POPE'S HILL, POPE'S ROAD, CORK CITY – LRD HOUSING

Architectural Response to Requests for Further Information

Planning Application No: 26/44677

Date: 10.08.2026

Revised Site Layout Plan

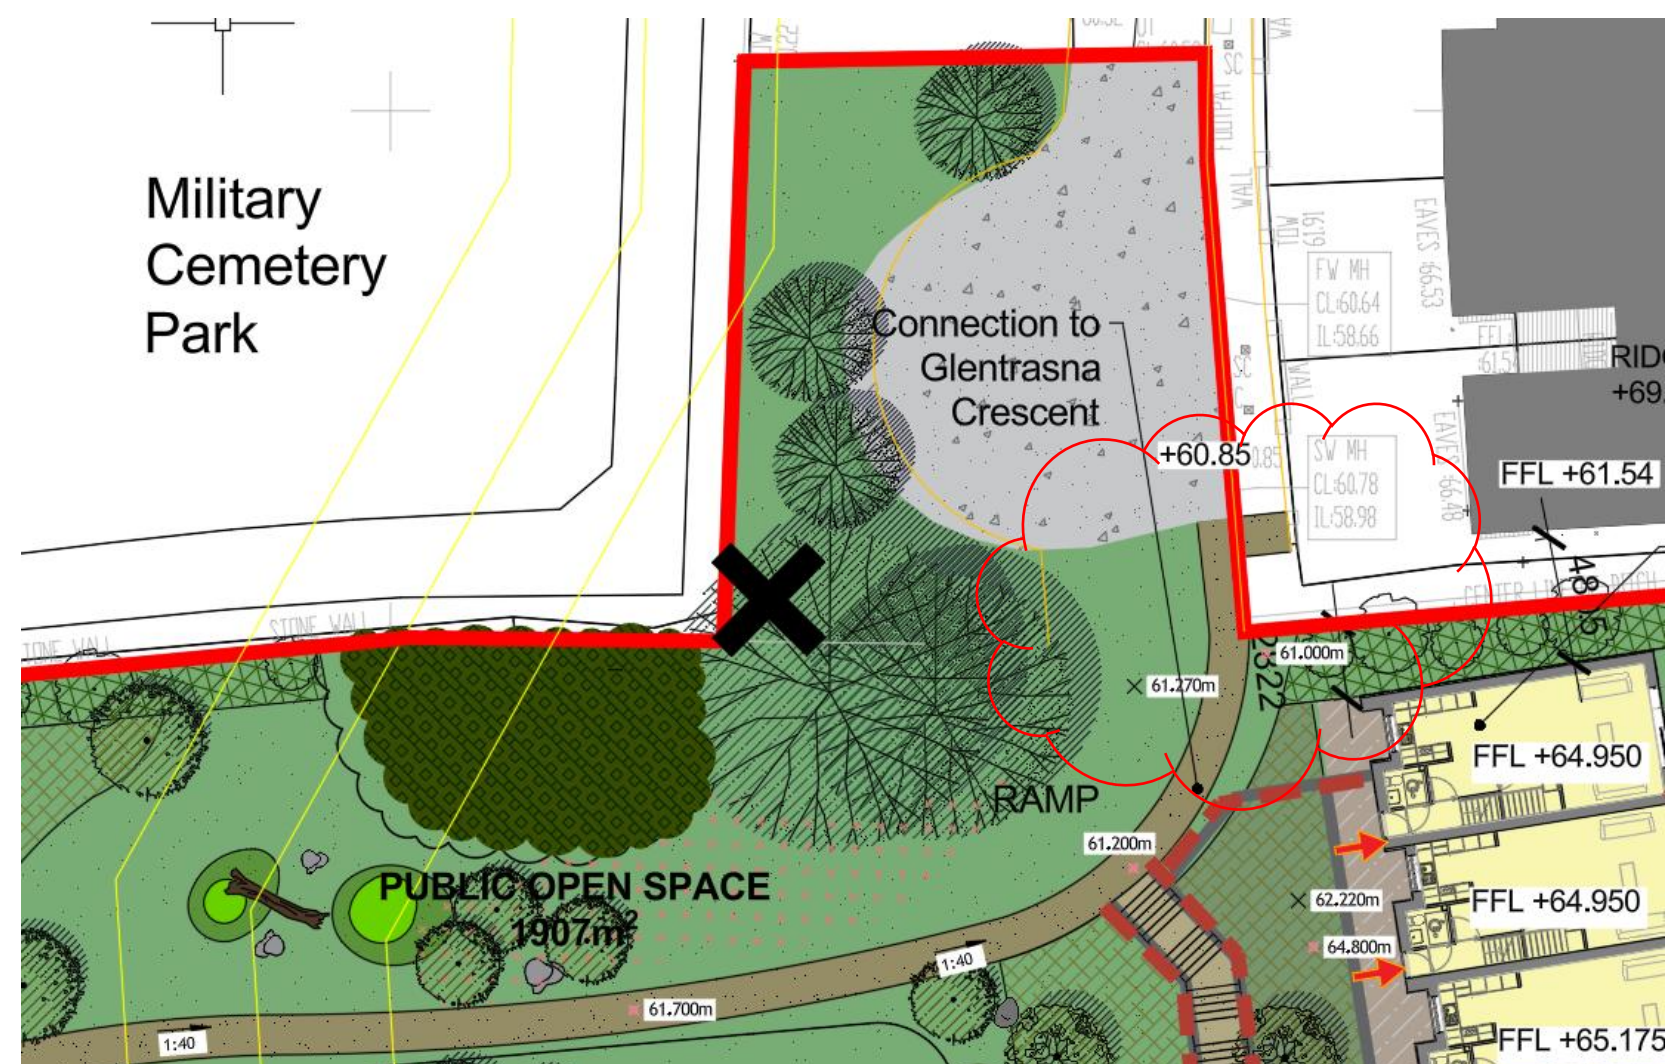
The Planning Authority notes that 78.4% of the proposed dwellings are 3-bedroom townhouses, exceeding the maximum percentage set out in Table 11.8 of the CCDP. No market-based evidence has been submitted to justify the proposed mix.

- The proposed unit mix has been reviewed against the requirements of Objective 11.2 and Table 11.8 of the Cork City Development Plan.
- The housing mix has been revised to provide a more balanced distribution of dwelling types across the development.
- The revised scheme now provides 26 No. 2-bedroom units (25%) and 52 No. 3-bedroom units (50%) within the overall development of 104 dwellings, significantly reducing the proportion of 3-bedroom units compared with the original proposal.
- A Market Demand Assessment has been prepared and submitted to demonstrate current housing demand and to support the proposed dwelling mix where appropriate.
- An updated Schedule of Accommodation accompanies this response.

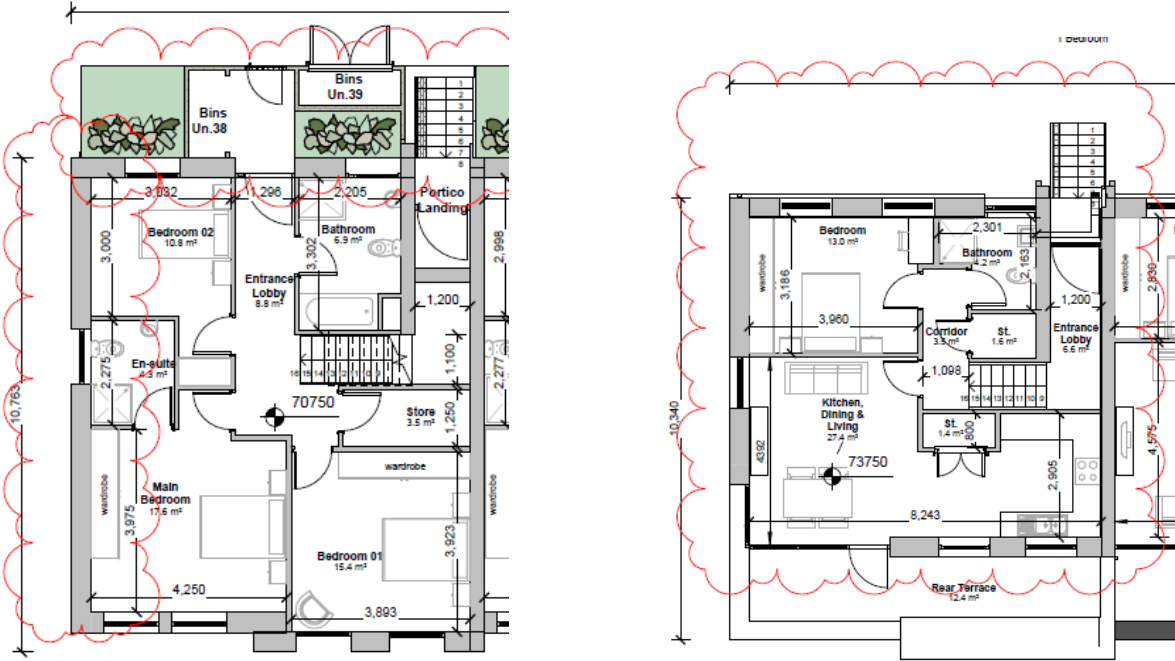
Please revise Block F by removing one bay to allow the road to move south and achieve a more consistent 20m buffer.

- The height of the end unit within Block F has been reduced by one storey to minimise its visual impact on the adjoining properties.
- Relocation of the internal road, as requested, is not feasible due to the existing site topography and gradient constraints. Moving the road would result in unacceptable road gradients and level changes.
- While the road alignment has been retained, the reduction in the height of the end unit improves the relationship with the existing dwellings at Glentrasna
- It should also be noted that there is a significant 18m buffer between the proposed properties and the existing dwellings, with no overlooking arising from the revised arrangement.
- Revised site plan, elevations and sections have been submitted to illustrate the proposed amendments.

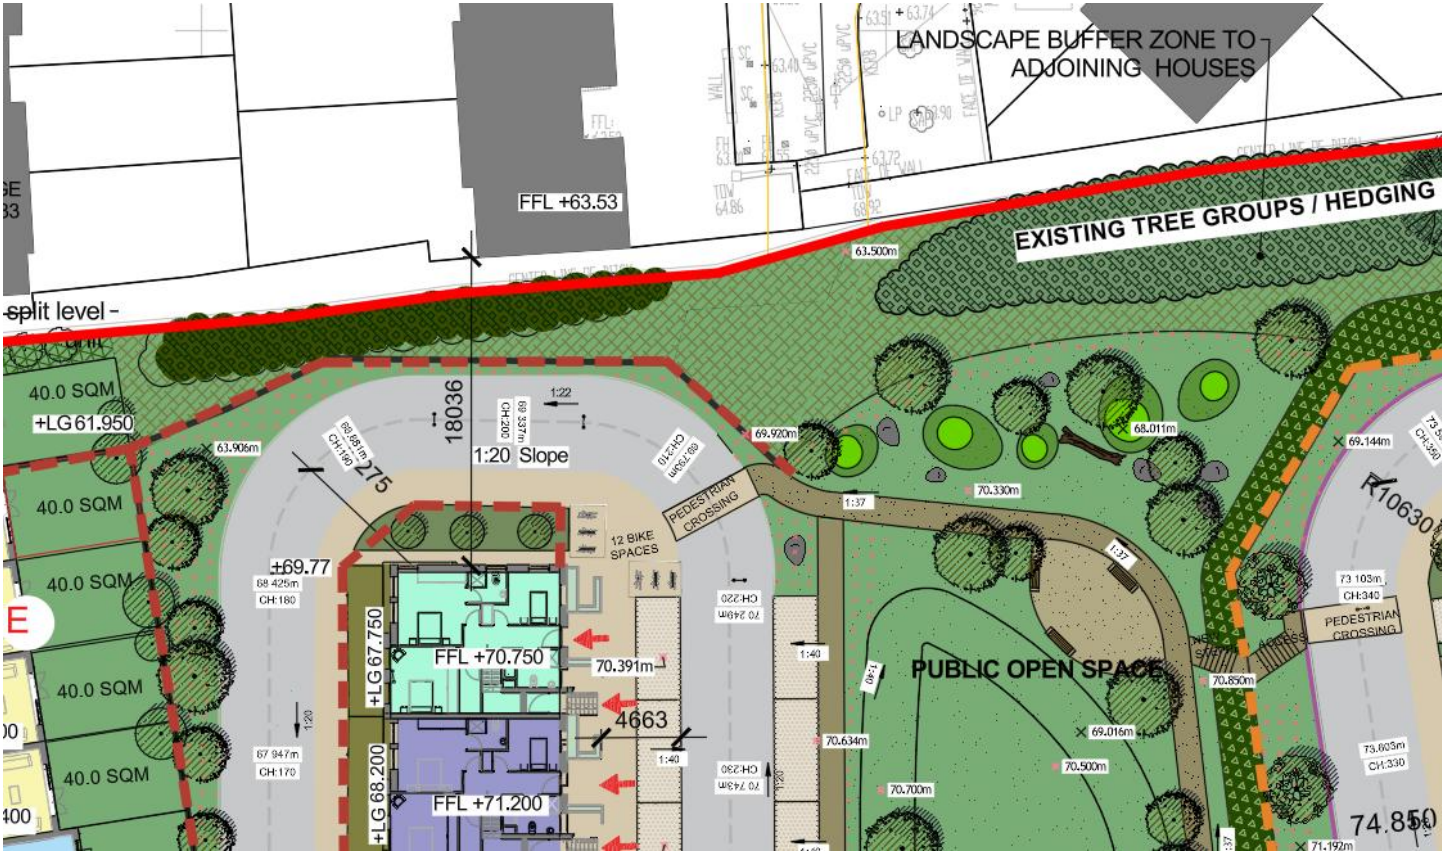
Revise the stepped access route or provide a fully accessible pedestrian/cycle connection benefiting from passive surveillance.

- The proposed pedestrian access to Glentrasna Avenue has been omitted from the revised scheme in response to the Planning Authority's request.
- The removal of the access simplifies the site layout and eliminates the previously proposed stepped connection.
- The omission of this access also responds to RFI Item 2 (Northern Boundary), which raised issues regarding the ownership and management of the strip of land to which the connection was proposed.
- The revised site layout has been updated accordingly.

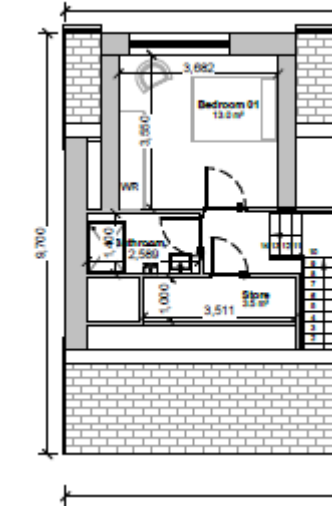
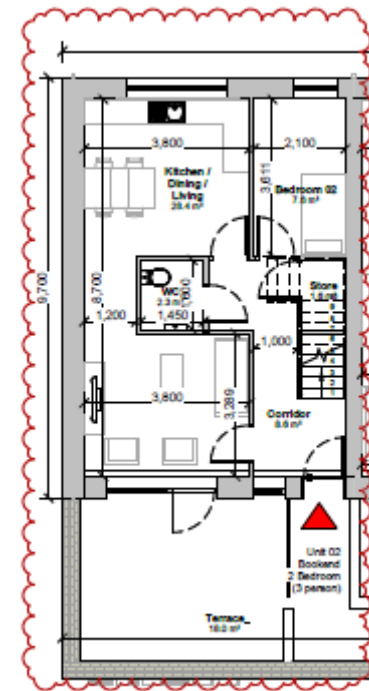
The proposed creche (Block B) is considered excessively prominent within the Area of High Landscape Value.

- The location of Block B has been revised, with the building moved further away from the site boundary to improve its relationship with the neighbouring properties along Pope’s Road.
- The overall massing of Block B has been reduced to minimise its visual prominence within the Area of High Landscape Value.
- The building height and roof profile have been amended to provide a more sensitive response to the existing ridgeline and surrounding landscape setting.
- Updated elevations, sections and visual material have been prepared to demonstrate the reduced visual impact of the revised proposal.

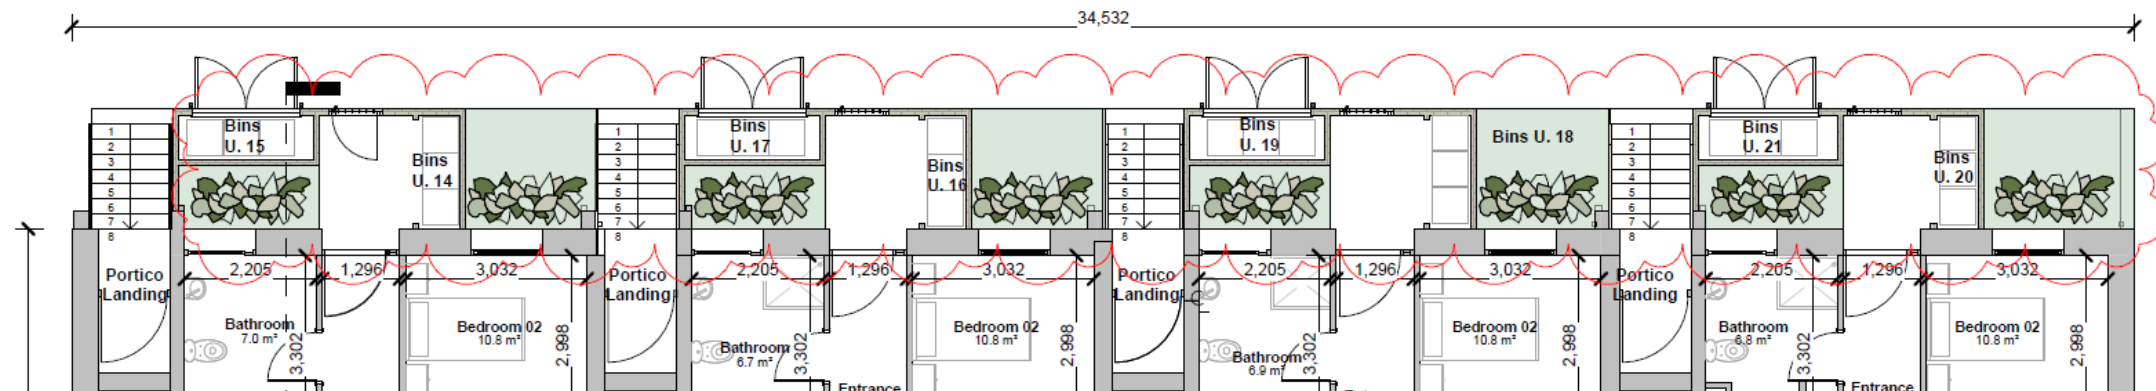
Apartment storage rooms exceeding 3.5m² are not considered acceptable.

- Apartment storage arrangements have been reviewed.
- Oversized storage rooms have been reconfigured by subdividing them into two smaller storage spaces to comply with the requirements of the *Sustainable Urban Housing: Design Standards for New Apartments Guidelines for Planning Authorities (2025)*.
- Individual storage rooms have been resized to ensure that no single storage room exceeds the 3.5m² maximum recommended area.
- Revised floor plans and the Schedule of Accommodation accompany this submission.

Revised Bin Storage – Block A

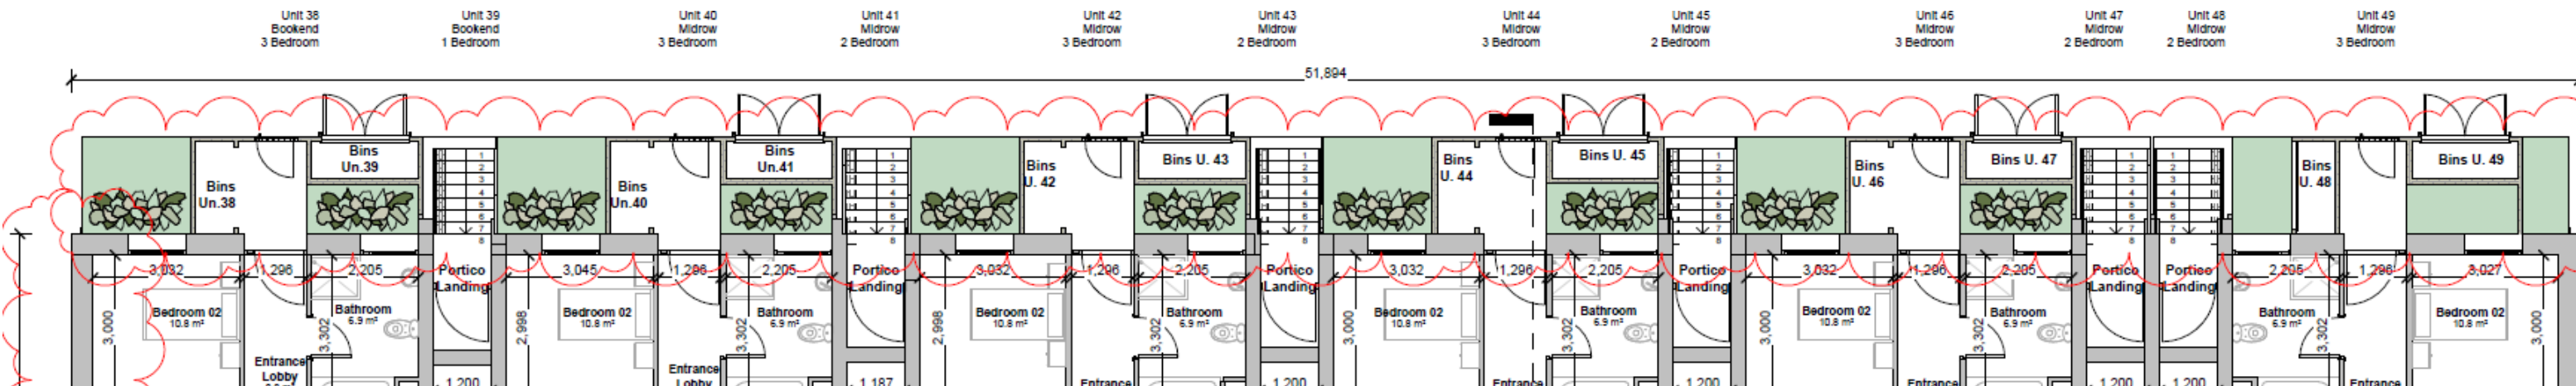
The proposed bin stores adversely affect the entrance to the development and the amenity of ground floor residents.

- Bin storage locations have been redesigned.
- Stores have been relocated away from residential windows where possible.
- Improved screening and landscaping have been incorporated.
- Waste collection arrangements remain fully accessible while improving residential amenity.

Revised Site Layout Plan – Creche Parking

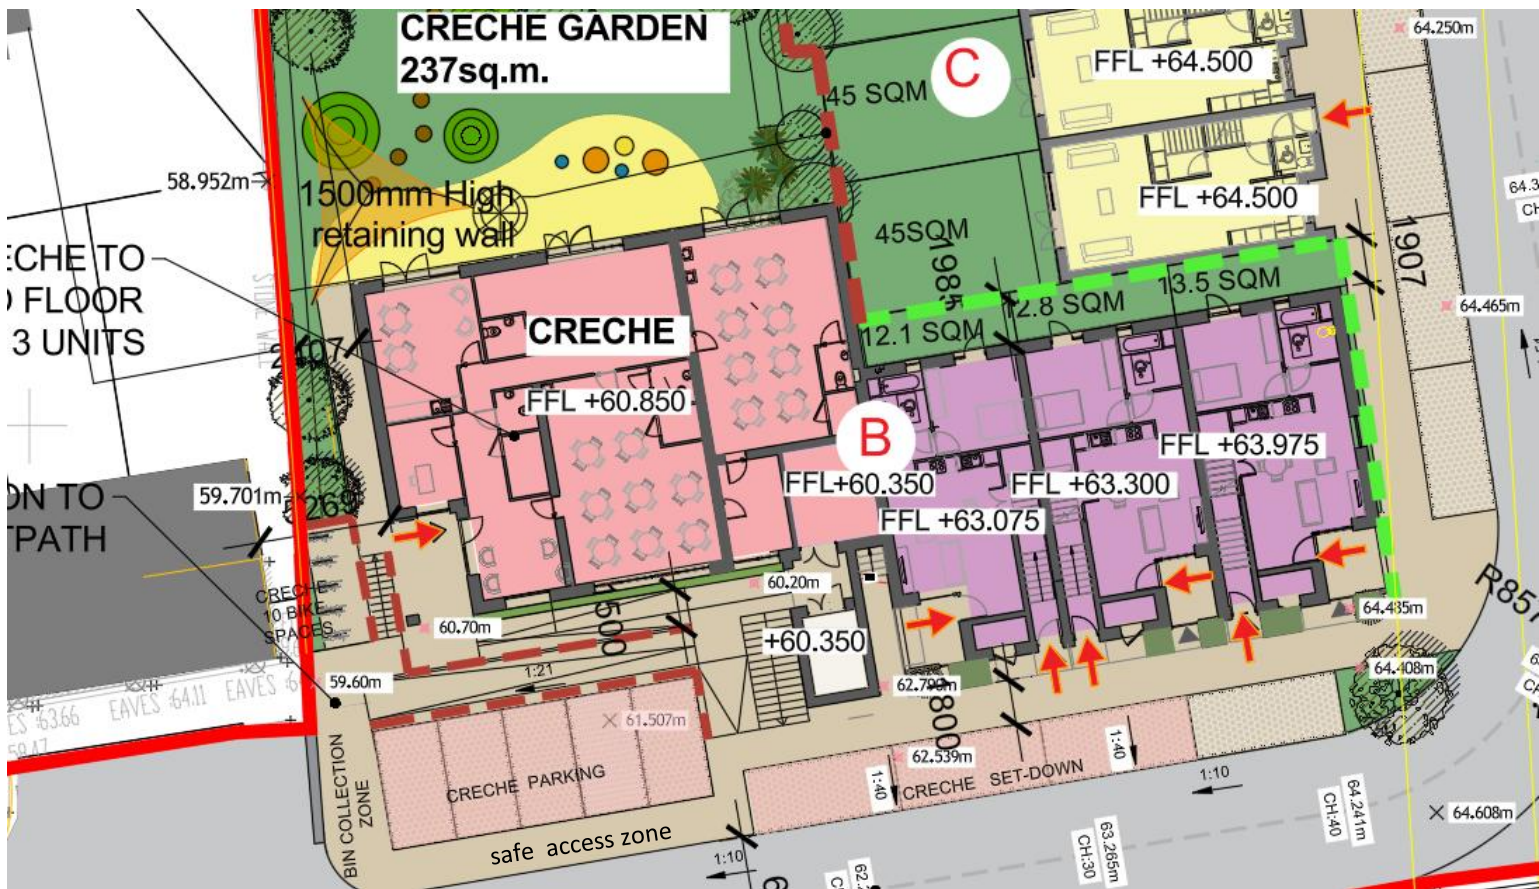
Clarify the operation of the creche drop-off, pick-up and turning arrangements.

- The creche access strategy has been reviewed.
- Dedicated drop-off and pick-up arrangements are clearly identified.
- Three dedicated parallel set-down spaces are provided, along with five perpendicular parking spaces. The perpendicular spaces are provided with a rear access zone, to allow additional manoeuvring space and improve safety during drop-off and pick-up periods.
- Pedestrian access has been separated from vehicular movements to improve safety for creche users.
- The revised site layout plan demonstrates the proposed parking, drop-off, circulation and access arrangements.
- Updated site layout drawings accompany this submission
